THE SHERWIN-WILLIAMS COMPANY  
Environmental, Health & Regulatory Services  
101 Prospect Avenue NW  
Cleveland, Ohio 44115-1075  
Facsimile: (216) 566-2730

March 27, 2006

**RE: Sherwin-Williams Co. Gibbsboro Sites  
Clarification of Items Related to XRF Screening at Hilliard Creek**

<b>LEGEND:</b>  <b>X</b> - SAMPLE LOCATION TYPICAL TRANSECT		<b>TITLE:</b>  PROPOSED SAMPLE COLLECTION LOCATIONS PLAN VIEW	
<b>PROJECT:</b> Gibbsboro RI/FS		<b>DATE:</b> Mar 14 2006	
<b>CLIENT NAME:</b> Sherwin-Williams Company		<b>WESTON</b> SOLUTIONS	<b>FIGURE #:</b> 1

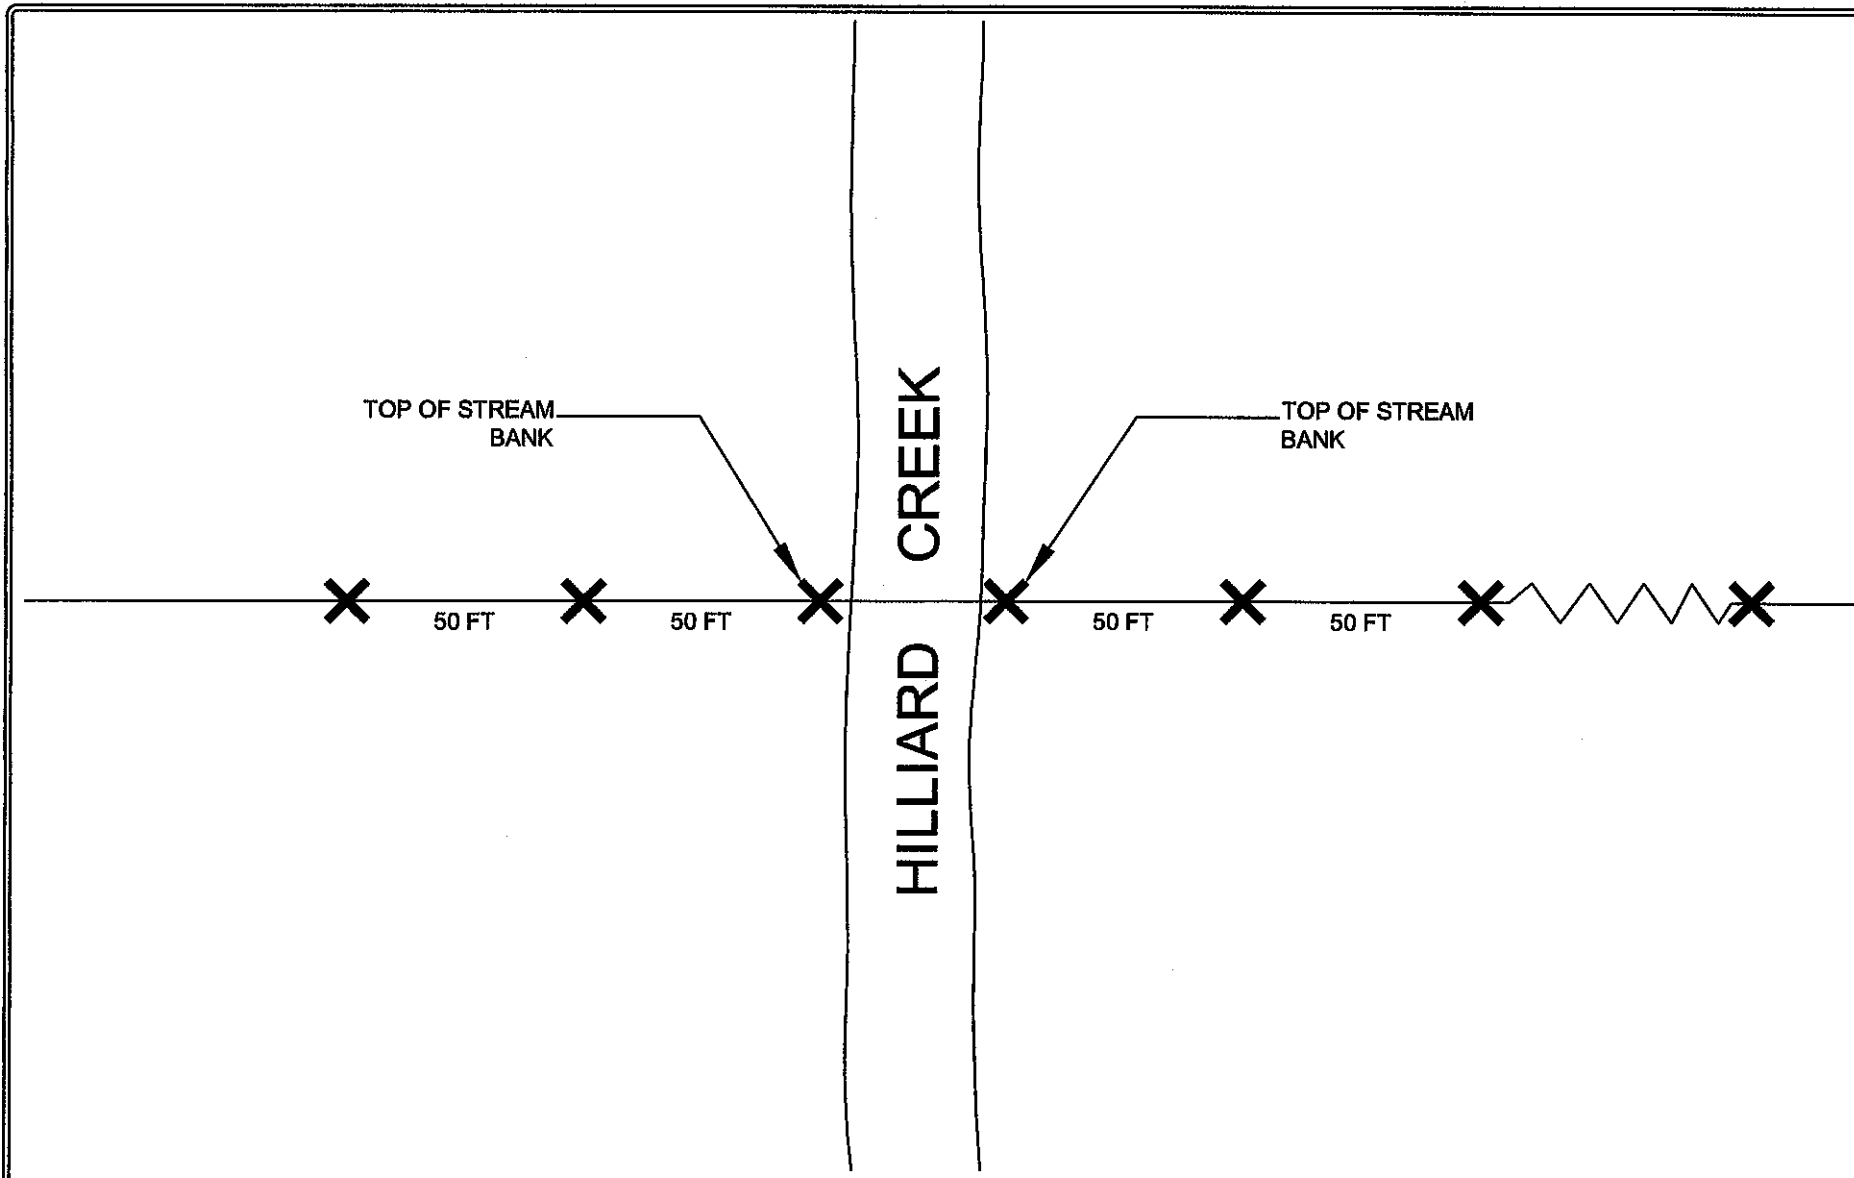
You requested in your March 8, 2006 note to me clarification of several items discussed in our March 6, 2006 letter requesting approval to use X-Ray Fluorescence (XRF) as a screening tool during the supplemental sampling that will be conducted in and along Hilliard Creek. Your note requested clarification of our proposal to modify the sample collection locations for each of the additional 200-foot transects along Hilliard Creek and of four specific items contained in our March 6, 2006 letter.

As you identified in your note, several terms were used in both our November 2005 and March 2006 letters, including "centerline", "top of stream bank", "shoulder of stream bank" and "perimeter". For purposes of further discussion of both our proposed sample locations and use of XRF for soil screening, the following two definitions are provided:

#### **2. Number of Samples from "Centerlines" and Rationale for Selection**

Figure 1 presents a plan view of the proposed sample locations. As shown, an initial boring would be installed at the top of the stream bank, followed by a second boring at a distance of 50 feet from the first. Samples would then be obtained every 50 feet until the boundary of the flood plain is reached (the perimeter sample). As we discussed at the December 7, 2005 meeting, there will be no loss of knowledge regarding the concentration or extent of the COPCs, as the information obtained from the five-foot interval samples was so similar.

The term "centerlines" should more accurately be stated as the "top of stream bank". As discussed above, in each transect borings will be installed in locations at the top of each stream bank. Therefore, all transects will have borings installed in two "top of stream bank" locations, one on either side of the stream, as reflected in Figures 1 and 2.
